Access Compliance Report

Public Rights-of-Way

(Curb Ramps)

Intersection ID: 12248	Main Street: E_8TH_ST	Cross Street: N_BREVARD_ST	Location: N
ADA ID: F381DF9DF6EE	Ramp Type: Perp	Initial Pass/Fail: Fail	Overall Compliance: No
Severity Score: 21.25			
Codes/Mitigation Info/Possible Solution		Field Measurements/Component Compliance

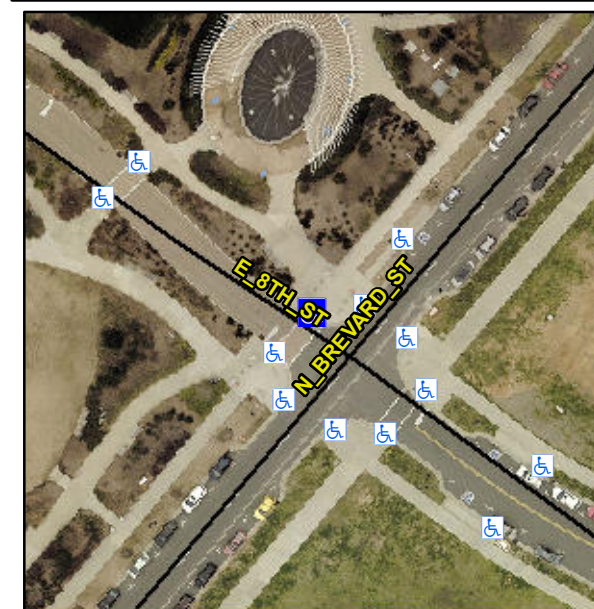
SLOPES VERIFIED & MATCH

R304.5.1, R304.2.2

Remove & Replace Entire Ramp.
